**LINCOLN PARK PLANNING COMMISSION**  
CITY HALL – COUNCIL CHAMBERS  
1355 SOUTHFIELD ROAD  
LINCOLN PARK, MICHIGAN

City of Lincoln Park,  
Wayne County, Michigan  
**SITE PLAN DOCUMENTS**  
Prepared For  
White Castle Systems

**PROJECT**  
White Castle Systems -  
DE #15 RP (Replacement)  
2115 Fort Street  
Lincoln Park, MI 48146

## Site Plan Review

**SHEET**  
General Site Plan

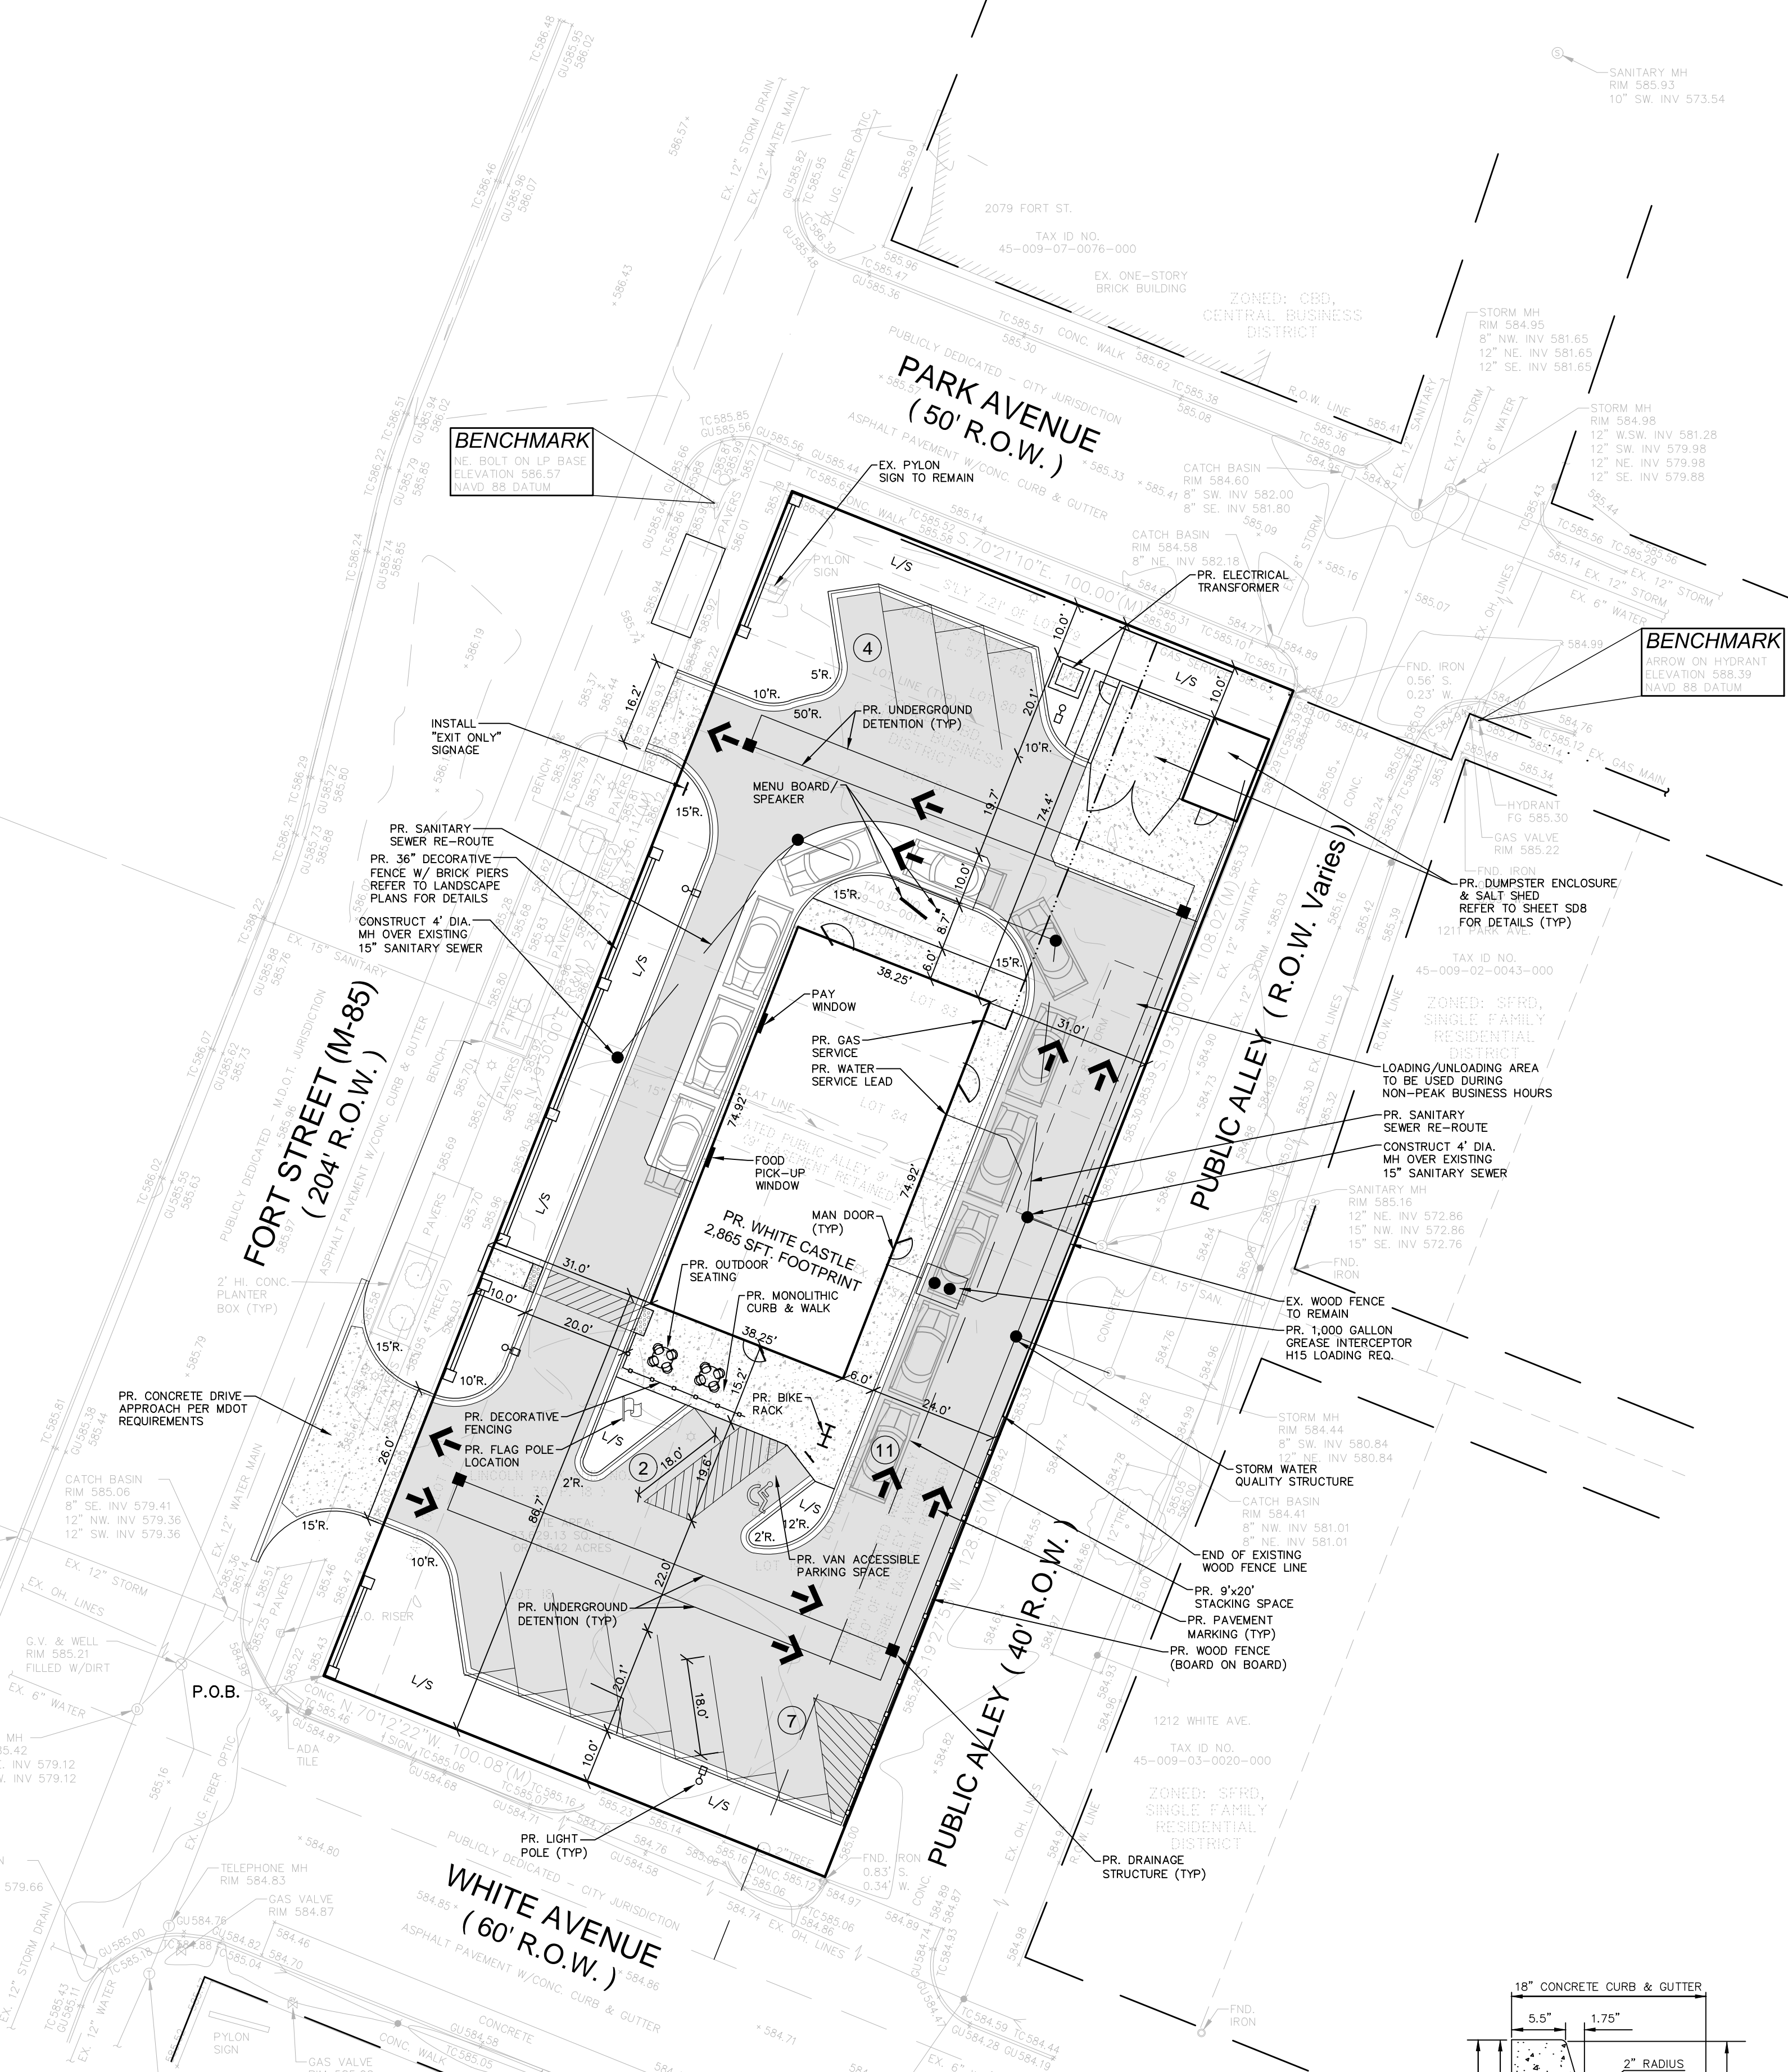
- Applicant to provide number of seats, square footage of usable customer area other than in an established seating plan area, number of employees on max employment shift
- Applicant to document that the proposed number of parking spaces can effectively accommodate the needs of the use without negatively impacting traffic safety or adjacent uses
- Ornamental 6' masonry wall to be provided along east side of parcel

As proposed, this site design does not meet the access standards of section 1290.10. The biggest source of noncompliance is the north, exit-only driveway. The ordinance-driven solution is to locate the second driveway on Park Avenue, though this may no longer fit local preferences. The Planning Commission should discuss the available options and solutions with the applicant and, if necessary, the City Engineer and the Michigan Department of Transportation.

- A strategy to address compliance with the City's access management standards should be discussed with the Planning Commission, the applicant, and other parties as necessary, notably the City Engineer and the Michigan Department of Transportation.
